**TAMPA-HILLSBOROUGH COUNTY
EXPRESSWAY AUTHORITY**

Letter of Clarification No. 2

REL Construction of Aesthetic Lighting

ITB O-00320

TYPICAL ITS CABINET POWER ONE-LINE DIAGRAM

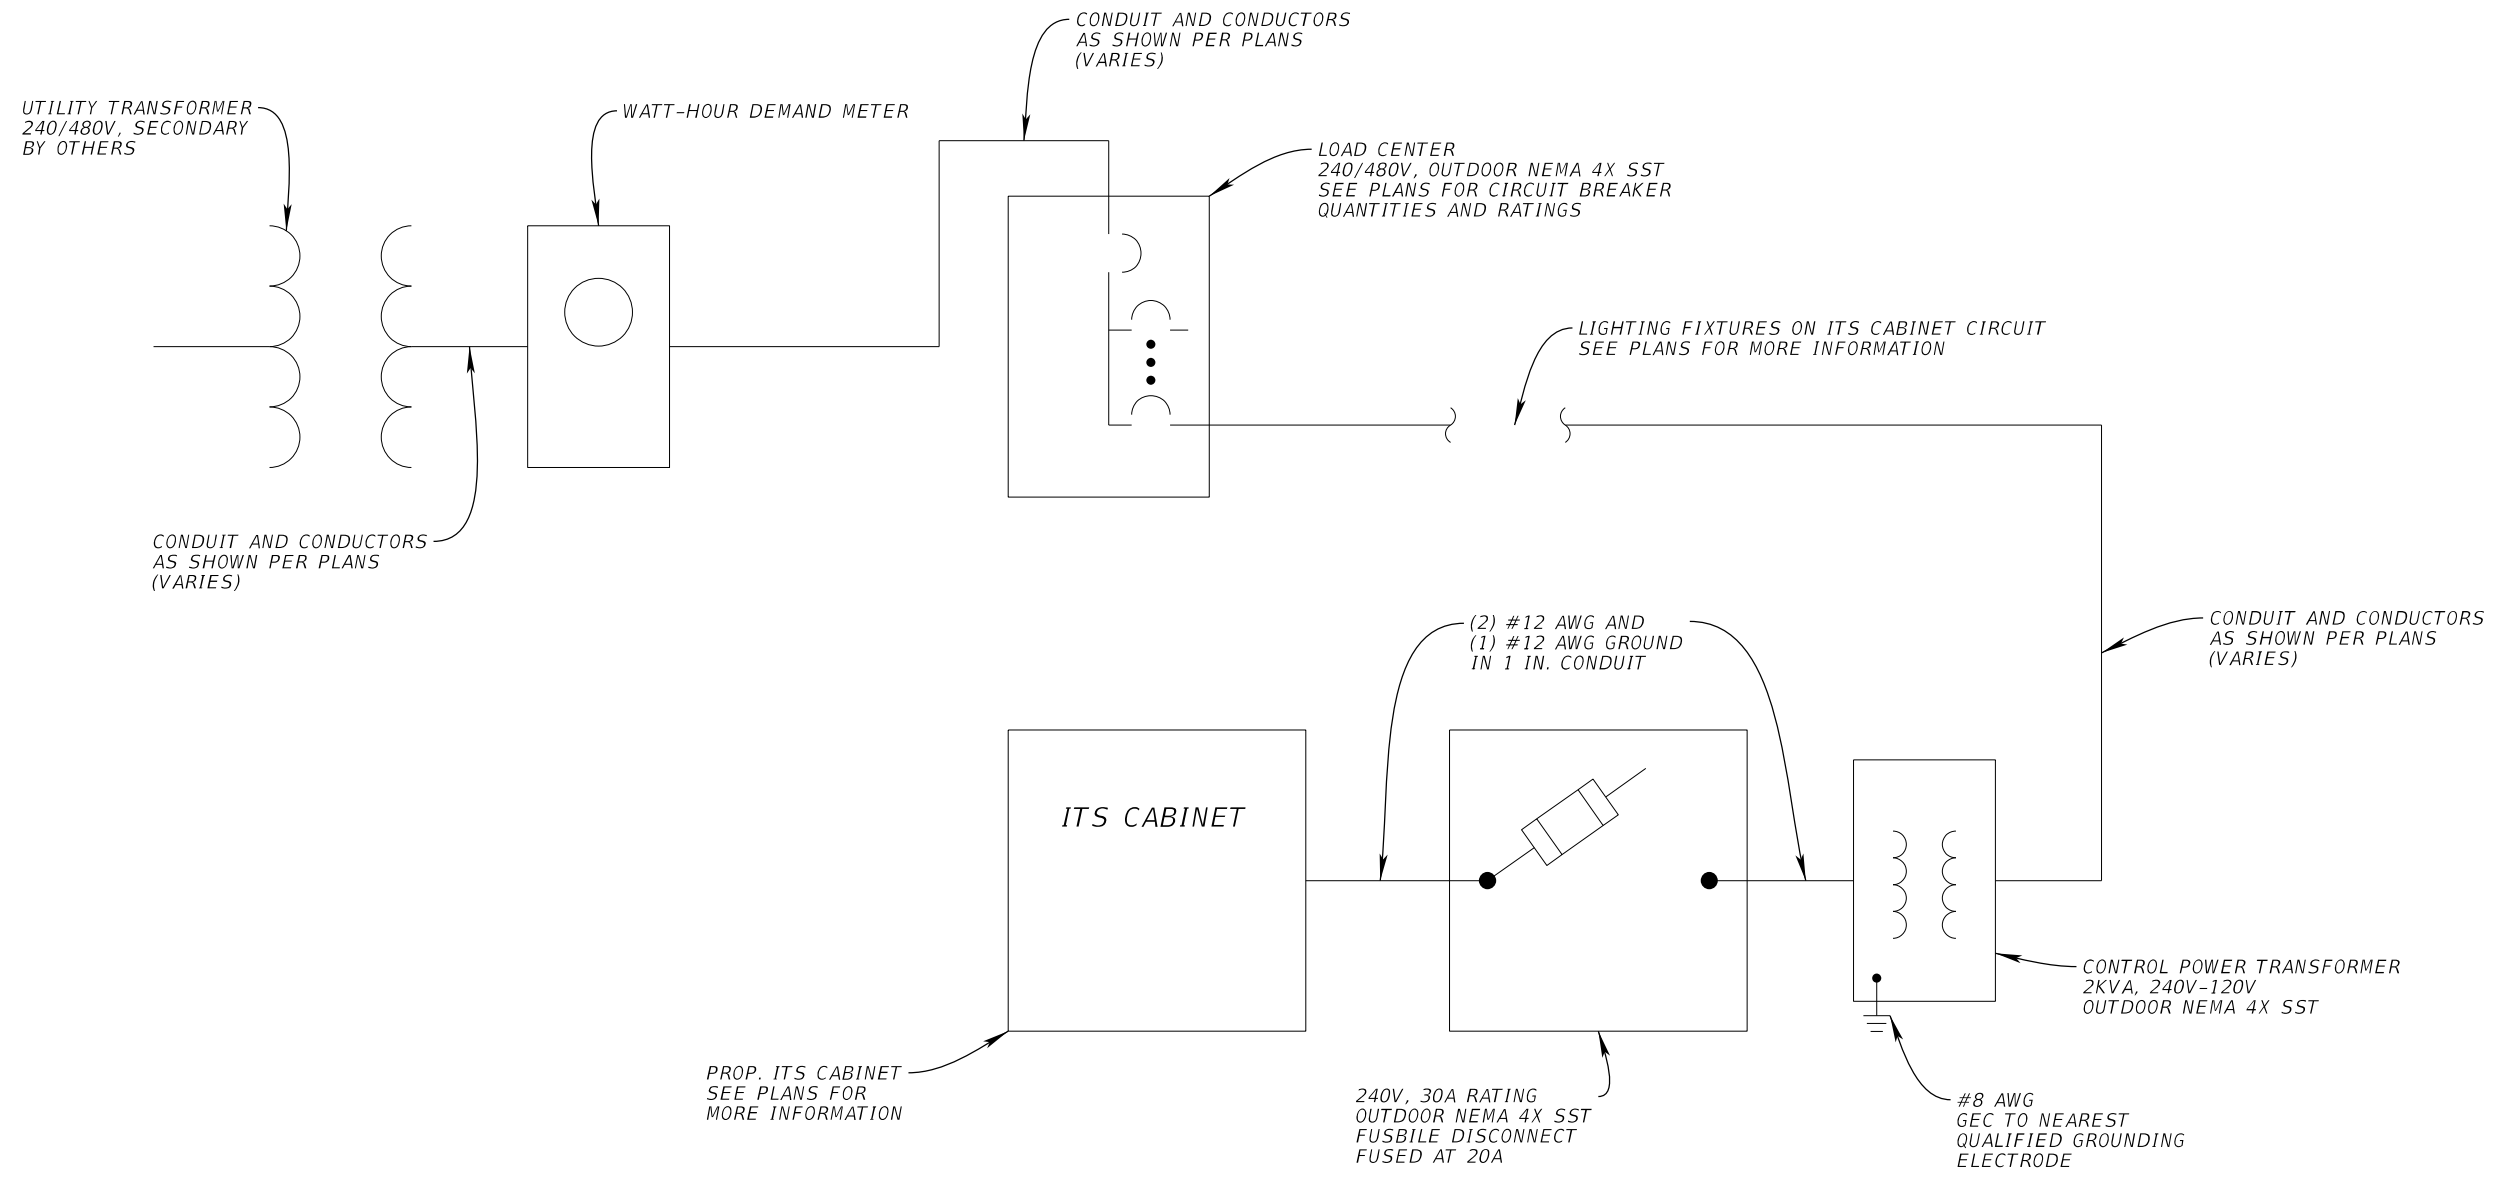
Response 5:	Where more stringent guidelines are present in the NEC those guidelines will govern.
Question 6:	Is there a one line electrical wiring diagram that can be provided for the Electrical Services; Pay Items 639-1-121, 639-3-11 and 639-6-1?

Response 6:	See attached one line diagram along with plan revision.
